UNITED STATES PATENT AND TRADEMARK OFFICE

APPLICATION NO.	FILING DATE	FIRST NAMED INVENTOR	ATTORNEY DOCKET NO.	CONFIRMATION NO.
10/790,230	03/02/2004	Gansha Wu	42339-193222	9836
26694	7590	08/21/2006	EXAMINER	
VENABLE LLP P.O. BOX 34385 WASHINGTON, DC 20045-9998			LEWIS, CHERYL RENE A	
			ART UNIT	PAPER NUMBER
			2167

Office Action Summary

DETAILED ACTION

FIG. 1

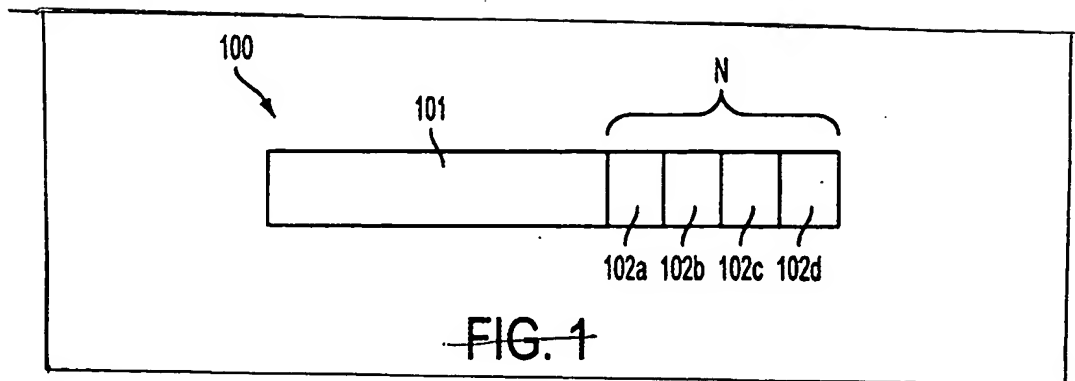
2. The drawings are objected to because drawing figures 1, 2, and 4-7 depict a partial view of the drawing figures. A box and/or a line drawn around each individual drawing figure is needed to show each individual figure as a separate entity (MPEP 37 CFR 1.84(h)).

The "N" variable is identified in the drawings of figure 1 and in the Specification. In the Specification, page 5, paragraph 00019, the "N" variable is identified as a number of bits. However, the applicants have failed to identify the "K-bit", particularly the "K" variable has not been identified.

As a convenience to the applicants, the examiner has attached an amendment of drawing figures 1, 2, and 4-7 to show by example, how to effectively amend drawing figures 1, 2, and 4-7.

3. The drawings are objected to under 37 CFR 1.83(a). The drawings must show every feature of the invention specified in the claims. Therefore, the "K-bit" must be shown or the feature(s) canceled from the claim(s). No new matter should be entered.
